VERMONT YANKEE NUCLEAR POWER STATION
TECHNICAL EVALUATION REPORT OF THE
IPE SUBMITTAL
HUMAN RELIABILITY ANALYSIS

FINAL REPORT

Final Report, November 20, 1995

FIGURE 3.3.2
Human Error Probability Response Curves from Swain

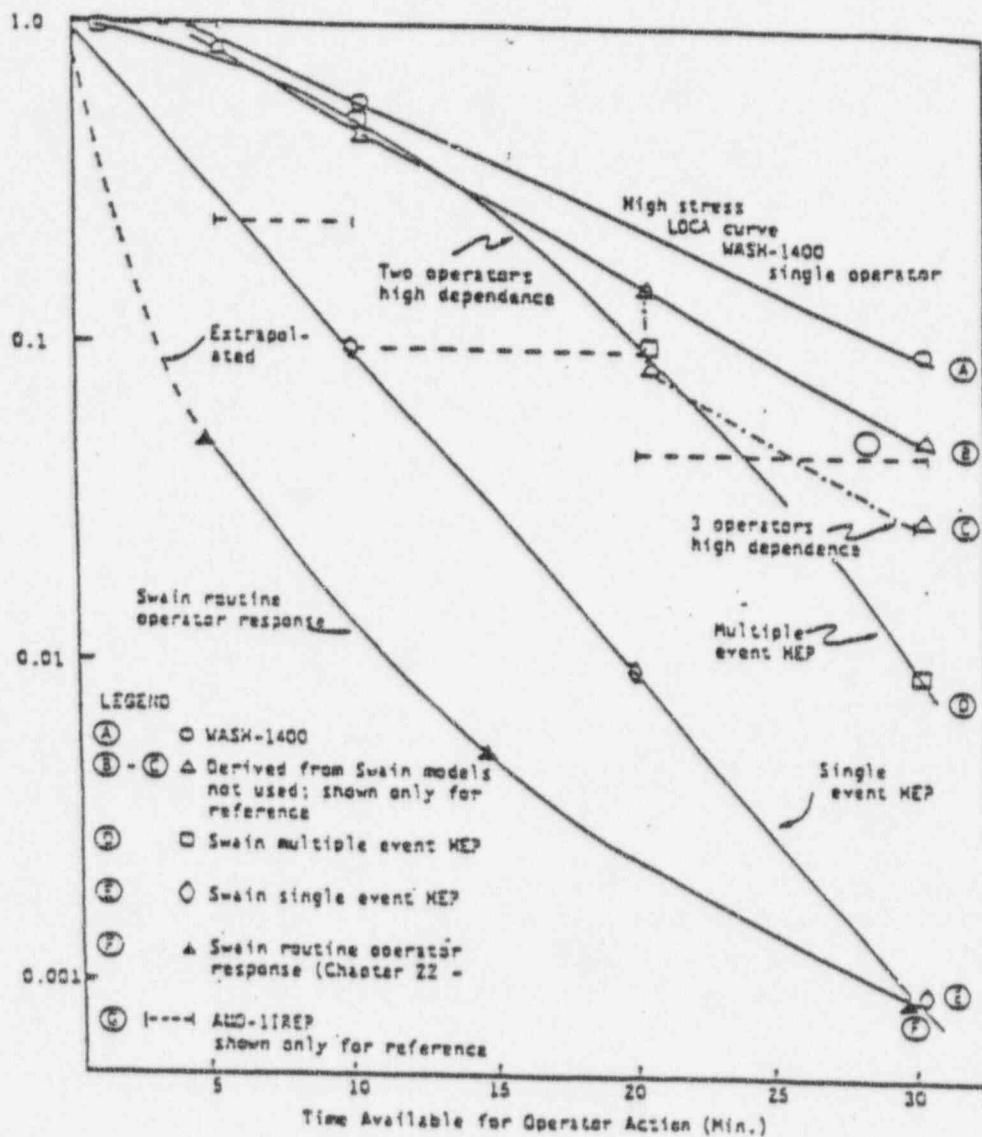
Exhibit A to this report is a reprint of IPE Figure 3.3.2, the time correlation curves used by the licensee to quantify seven (7) operator actions with the VY TRC method. The licensee states that these curves were derived from NUREG/CR-1278 (Reference 2), WASH-1400 (Reference 3), and NUREG/CR-2815 (Reference 4) for different performance shaping factors (PSFs) such as type of action, degree of difficulty, and stress level. Sensitivity to plant-specific factors is not discussed. Curves A through F represent the time-dependent "cognitive" HEPs given various PSFs. Interpolation is performed to quantify HEPs for the medium-term and long-term response times. Generally, the licensee used a HEP value of $1.0E-04$ for medium-term responses and $1.0E-06$ for long-term responses. A manipulative error (taken from the EPRI method) is added to the cognitive HEP to calculate the total HEP for a given action. The specific operator actions quantified with this method are listed in Table 2-1.
